Wollongong Local Planning Panel Assessment Report | 22 May 2019

WLPP No.	Item No. 2
DA No.	DA-2018/1231
Proposal	Alterations and additions to North Wollongong Surf Lifesaving Club
Property	Lot 3, DP 1136814, Reserve D580060 Stuart Park, George Hanley Drive, North Wollongong
Applicant	Borst & Co Architecture
Responsible Team	Development Assessment and Certification - City Centre Team (RW)

ASSESSMENT REPORT AND RECOMMENDATION

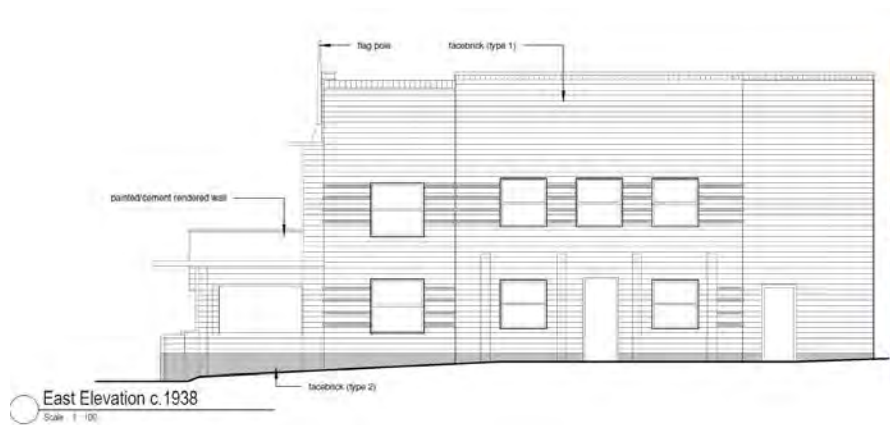
1. **Proposed Balcony**

The proposed addition of the eastern veranda to the original 1936 building has been raised as a matter of concern in a number of submissions and is noted as not being consistent with the CMP policies relating to additions. The proposed inclusion of this addition has the potential to obscure the vertical pillar details which were a significant architectural feature of the historic building, providing physical separation of the original window openings and visual relief and interest to the façade. Further, this addition has led to a proposal to include a large bi-fold door opening to the 1st floor of the façade of the 1936 building. These modifications, whilst impacting on altered fabric result in a substantial visual modification to the original building as viewed from the beach.

The proposed balcony along the eastern elevation of the building should be reduced in scale to reduce visual impacts on the relationship of the SLSC building and the SHR precinct. The balcony should be removed from the eastern façade of the 1936 building and be limited to the 1989-90 phase of development. This compromise provides the amenity of the open balcony for the surf club, whilst limited the potential impacts of the proposal on the 1936 building.

This will likely require some level of reconfiguration of the internal spaces on the first floor, including the Bar Space.

The first floor balcony off the original 1936 part of the surf club building must be deleted from the plans. Plans demonstrating that this requirement has been met must be submitted to Council's Heritage planner for written approval prior to issue of the construction certificate.

Figure 1: proposed signage on western façade

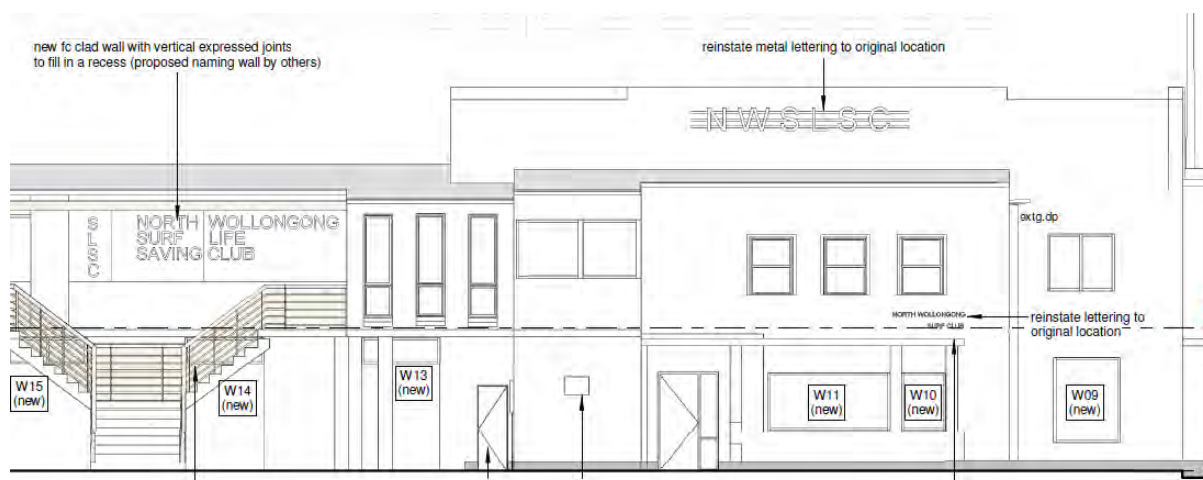
Approval is sought for three building identification signs on the western elevation of the building, one of which is the reinstatement of the 'NSWSLSC' lettering across the parapet as it appeared on the original building. The other two signs are additional signs (one on the first floor and the other on the ground floor at the southern end of the building), as shown below:

The proposed signage falls under the definition of 'building identification sign' as all three (3) signs will identify the building as the North Wollongong Surf Lifesaving Club. The applicant states that all existing advertising signage will be removed.

Figure 3: Map of North Beach Precinct identifying 'B' which is the location of a new SLSC to the north of the existing surf club building.

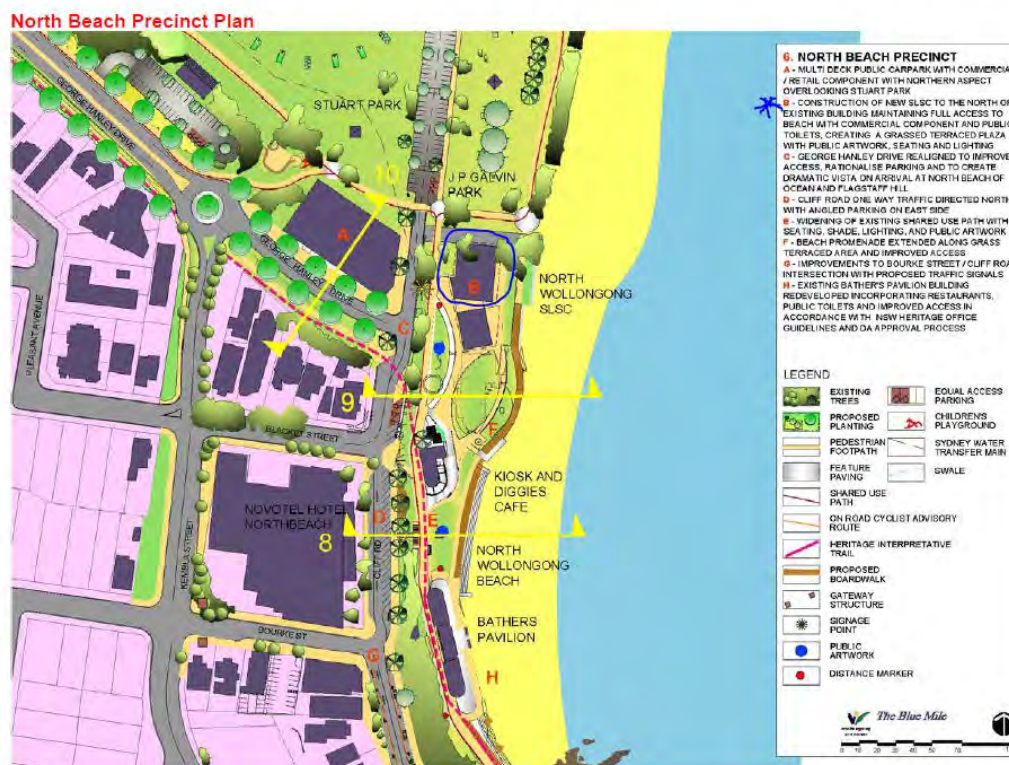
The Masterplan notes that structural investigations were carried out that revealed issues with the surf club building and identifies the following works within area '6 North Beach Precinct':

The masterplan identifies that the surf club building should be replaced with a building to the northwest of the existing building's location as shown in Figure 3 above.

Advice from the applicant indicates the works proposed in this application will provide sufficient protection for the building to extend its life, and that the replacement of the building is not proposed in the foreseeable future.

The proposed development will help to address the structural problems identified in the building, will improve functionality and amenity and will improve the visual amenity and enhance the heritage significance of the site and surrounds. On this basis, although inconsistent with the replacement of the surf club, the proposed refurbishment is consistent with the objectives of the Blue Mile Masterplan for the north beach precinct, and there are no other objections raised under this policy.

East Elevation
Scale 1:100

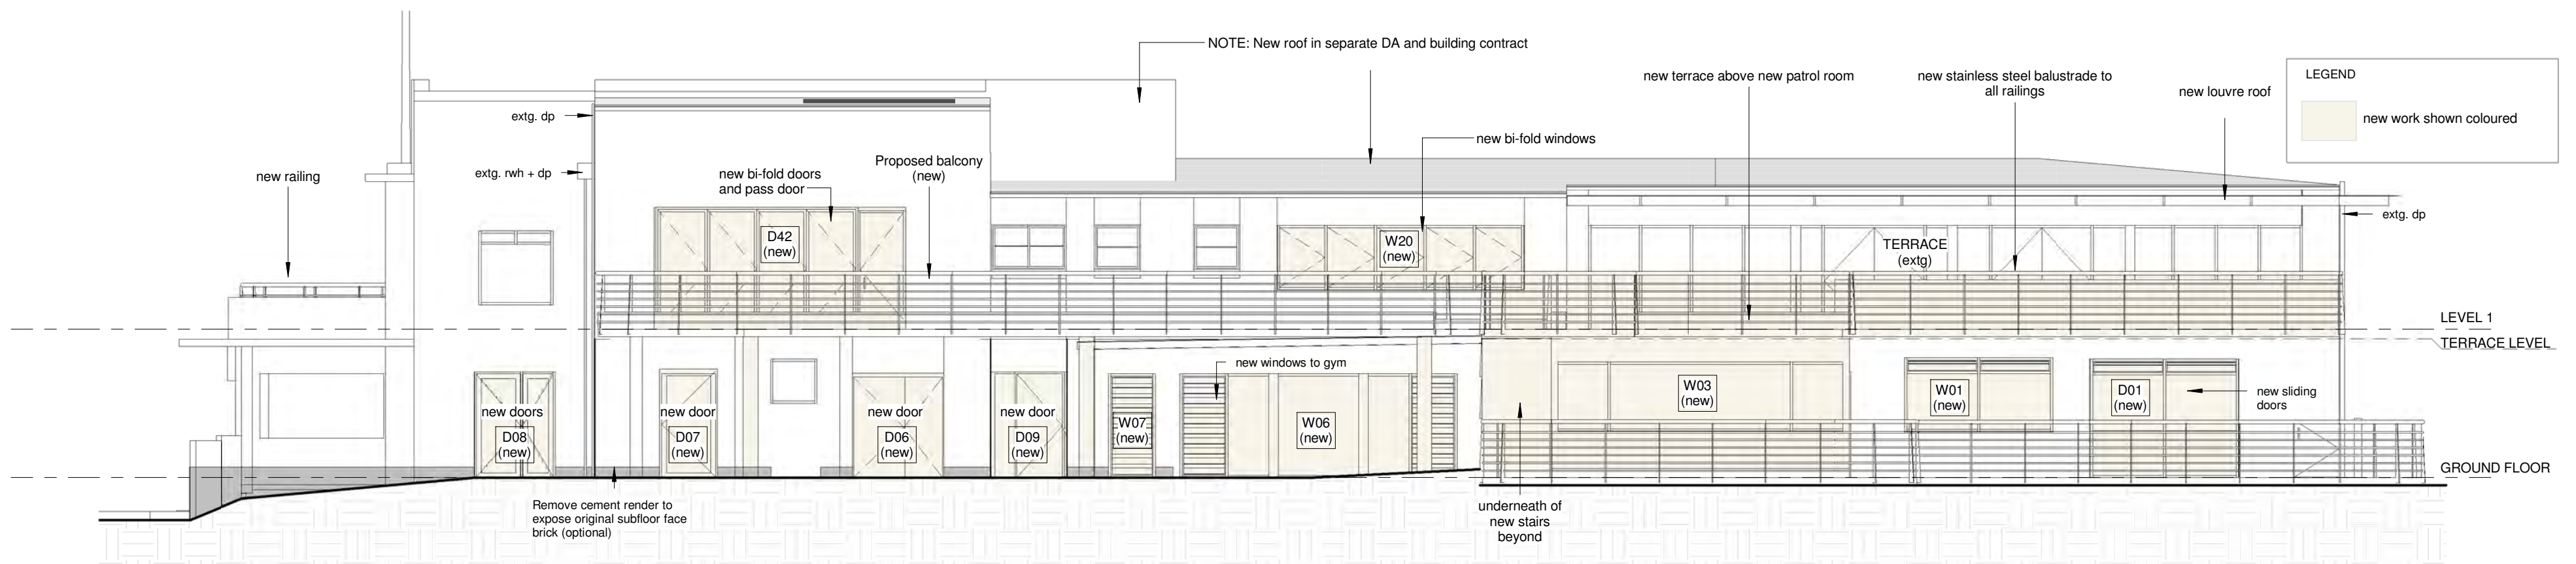
The proposed first floor deck and the new openings within the original 1936 portion of the building do not adequately respond to the Conservation Management Plan (CMP) that exists for the building. The CMP recommends that no new openings or intrusions should occur. Supporting these aspects of the development is considered to further erode the heritage significance of the building. These concerns were identified in the pre-lodgement meeting and in the requests for revised plans and additional information; however concerns raised by Council have not been satisfactorily addressed during the course of the assessment.

In order to respond to the recommendations of the CMP, the first floor balcony and bi-fold doors should be deleted from the proposal and changes to existing openings should match the style and configuration of original openings. Conditions are recommended to be imposed on the consent requiring revised plans to be submitted to Council's satisfaction prior to issue of a construction certificate, as follows:

East Elevation c.1938
Scale 1:100

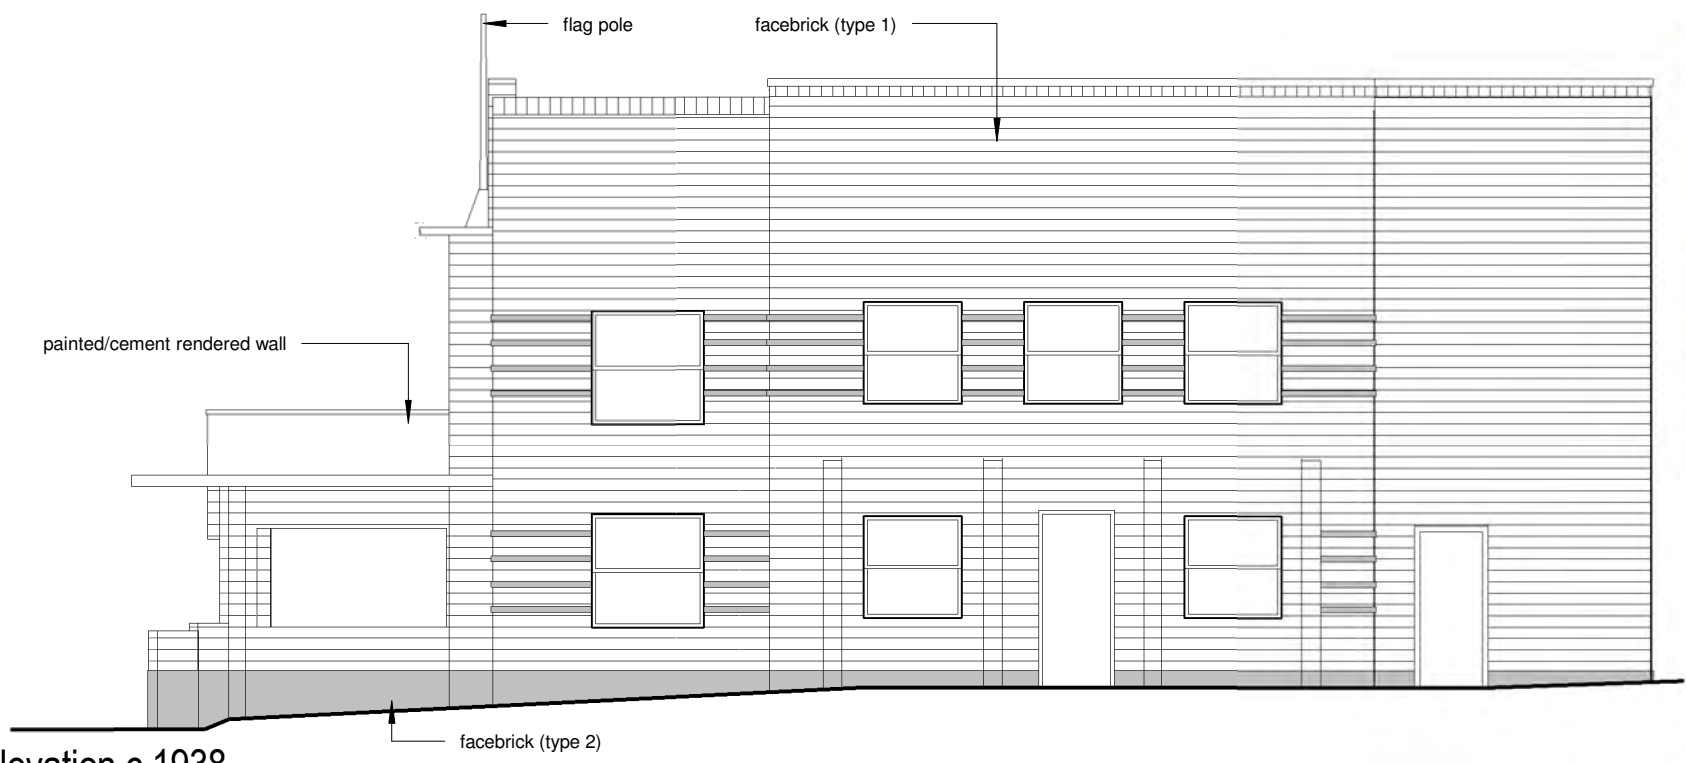
The original window and door opening configurations from the 1936 building should instead be reinstated as per the below plans (East Elevation c. 1938 on Drawing DA28).

The window and door openings identified as D06, D07, D08 and W08 on the ground floor and D42 on the first floor must be reinstated to reflect the original openings as depicted on the 'East Elevation c. 1938' on Drawing DA28. Plans demonstrating that this requirement has been met must be submitted to Council's Heritage planner for written approval prior to issue of the construction certificate.

The window and door openings identified as D06, D07, D08 and W08 on the ground floor and D42 on the first floor must be reinstated to reflect the original openings as depicted on the 'East Elevation c. 1938' on Drawing DA28. Plans demonstrating that this requirement has been met must be submitted to Council's Heritage Staff for written approval prior to issue of the Construction Certificate.
